# STERLING RANCH ROAD & BRIARGATE PARKWAY SEGMENT 2 STREET PLANS

## STREET IMPROVEMENT PLANS

DECEMBER 2022  
PCD FILING NO.: CDR221

**TYPICAL CURB & GUTTER DETAILS (SD 2-20)**  
SCALE: NTS

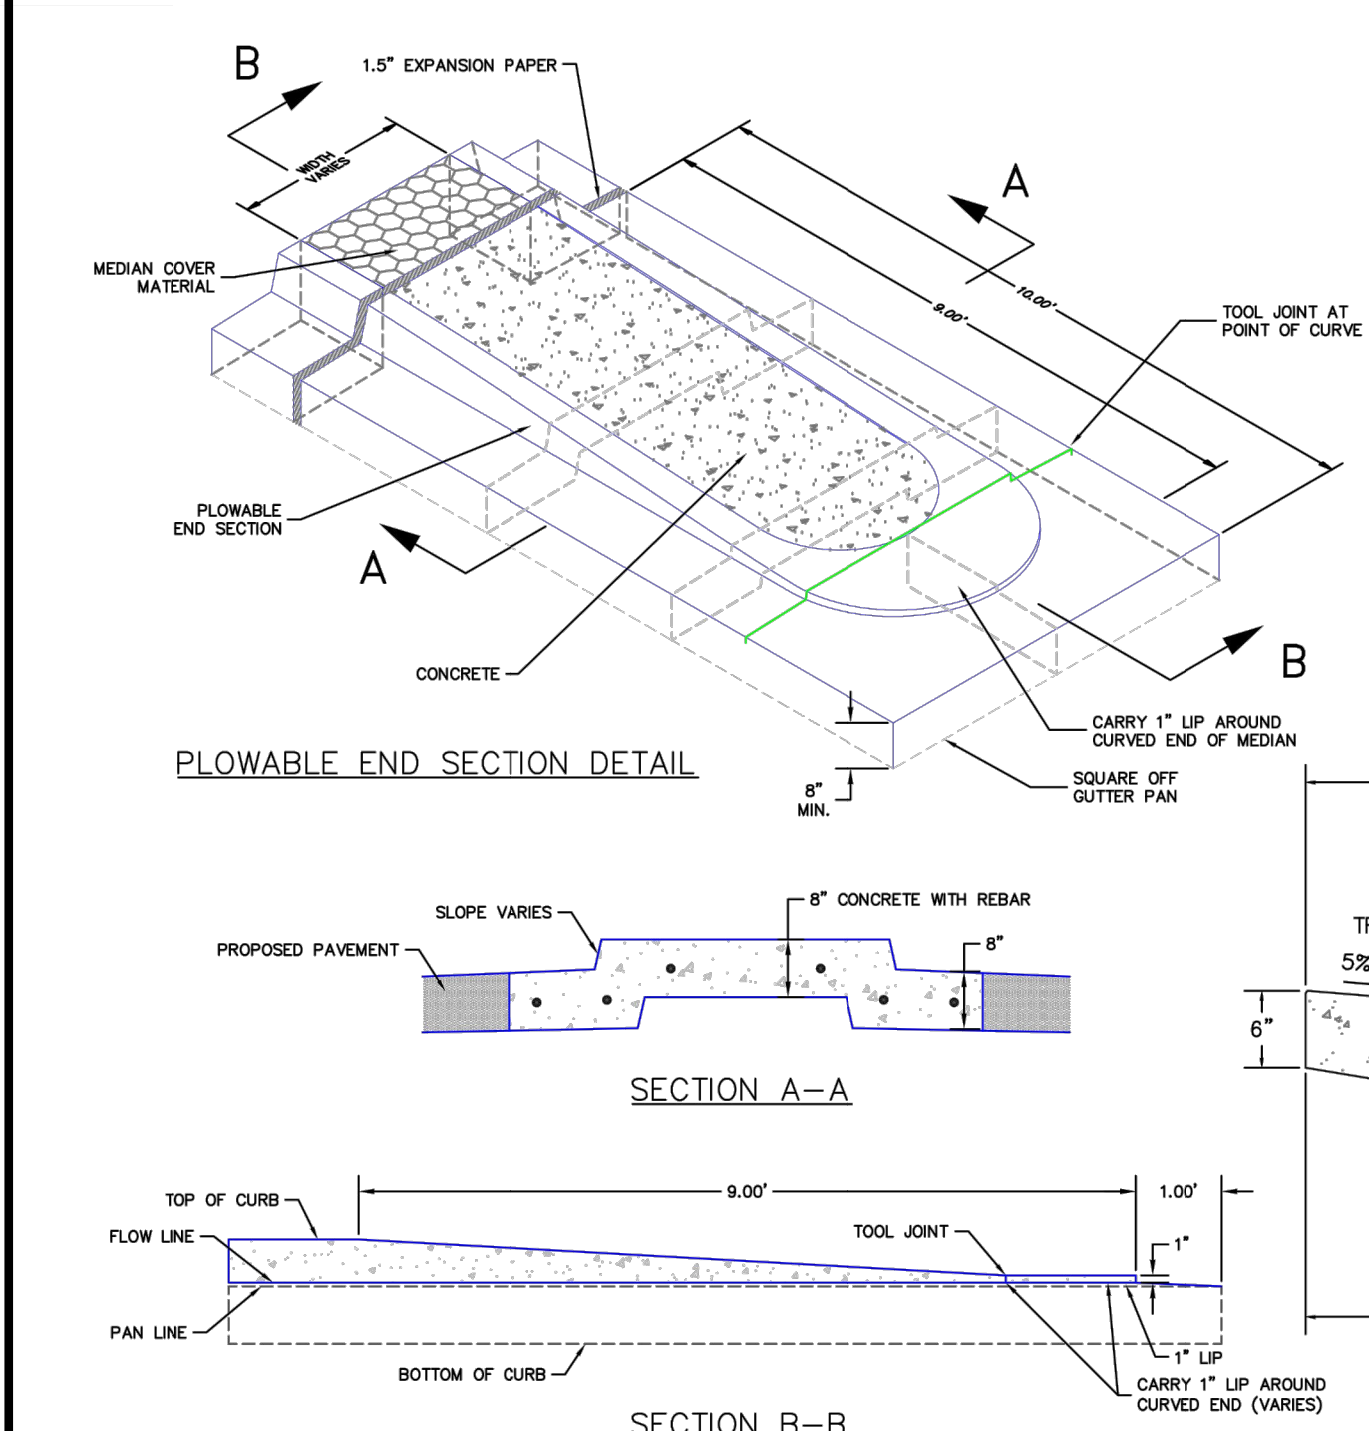
Include missing detail
